Subject: Planning Board Peer Review
Paragon Dunes Development
189 & 193 Nantasket Avenue, 0 George Washington Boulevard
Hull, Massachusetts 02045
CEC Project 334-762

On behalf of the Applicant for the above referenced property, Civil & Environmental Consultants, Inc. (“CEC”) has prepared this memorandum in response to comments provided in a memorandum from Chessia Consulting Services, LLC (“Chessia”), dated January 9, 2024.

APPENDIX A – VEHICULAR TURNING TEMPLATES

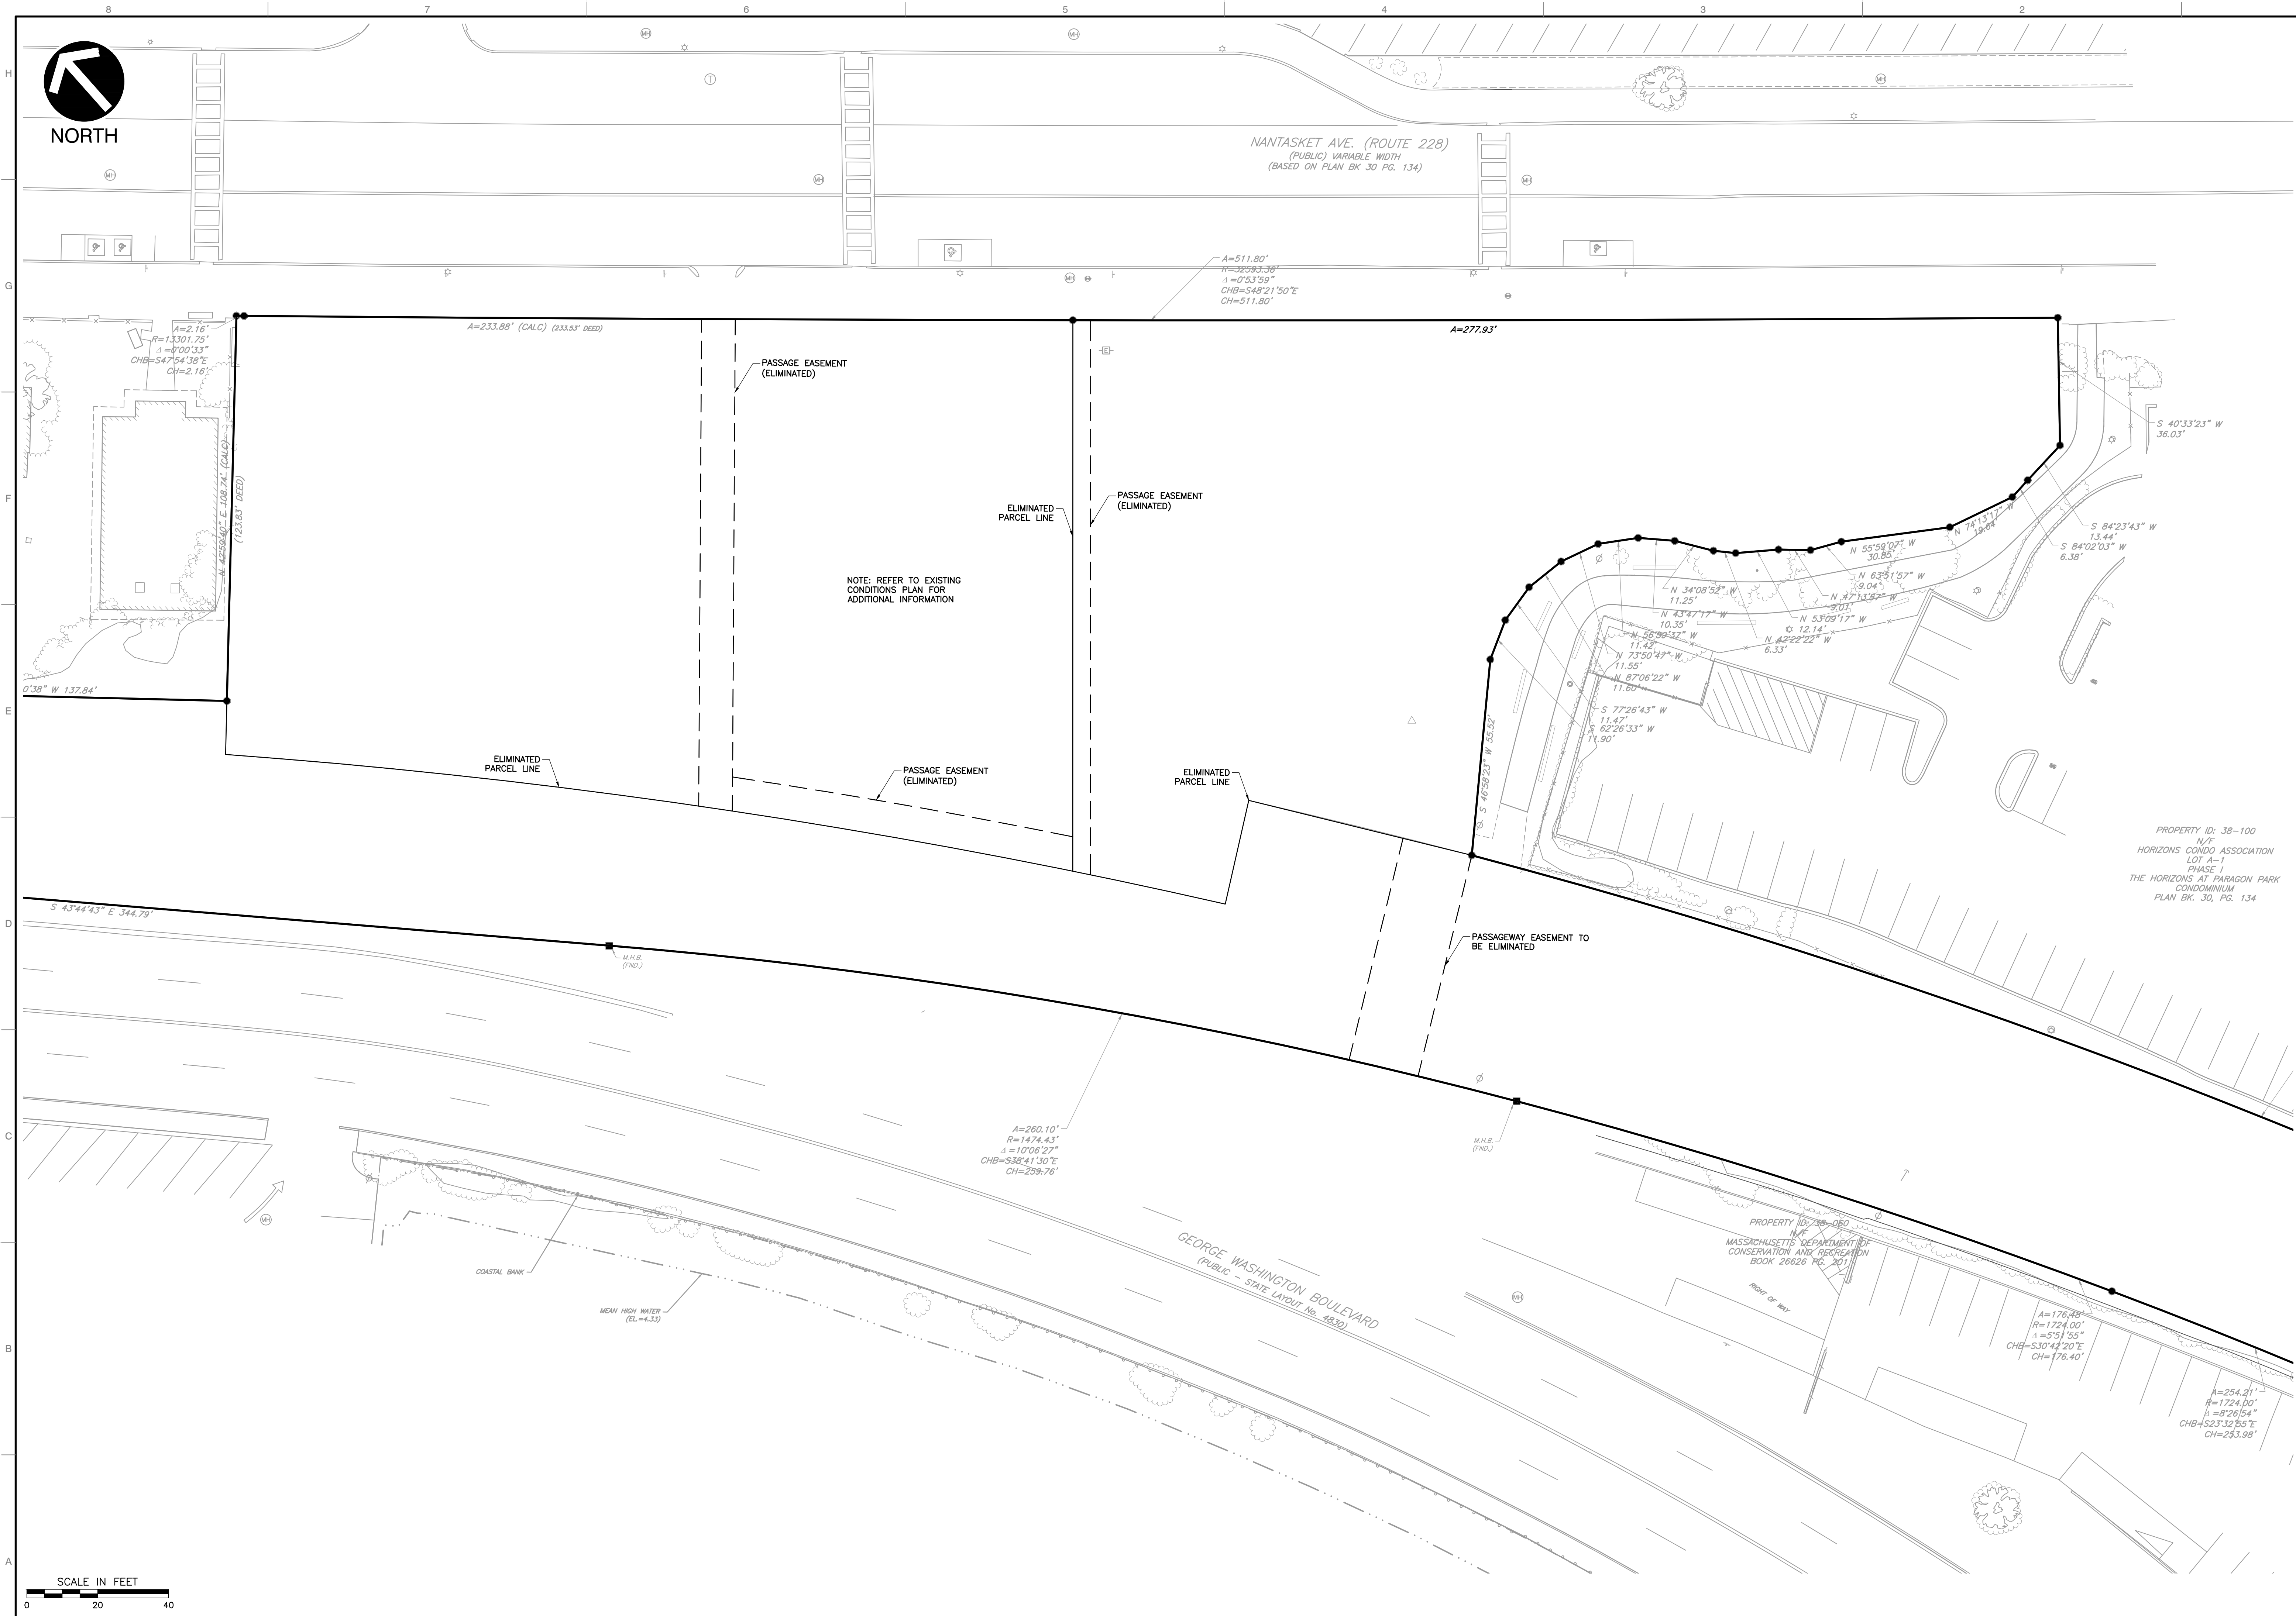
17. The submittal should discuss where and how moving vans, and commercial deliveries, etc. would service the project.

66. *As noted, I recommend that it be demonstrated how trucks will access the loading area and dumpsters. As noted how other deliveries, etc. would occur should be discussed. A*

CEC Response: See response above for discussion of loading operations. Truck turning exhibits have been prepared to demonstrate turning movements of typical vehicles that will access the site including a SU-30 Box Truck.

CEC Response: The trash pickup is anticipated to be provided with vehicles entering the westerly parking and loading area from George Washington Boulevard. Trash will be stored internally that will serve the residential uses as well as the commercial uses. Trucks will access the trash room at the roll-up doors where vehicles will load and exist the site onto George Washington Boulevard. See turning templates for maneuvering of the trash pickup.

CEC Response: A photometric plan is being developed and will be provided to the Town for review. Vehicular turning templates have been prepared and are included as an attachment.
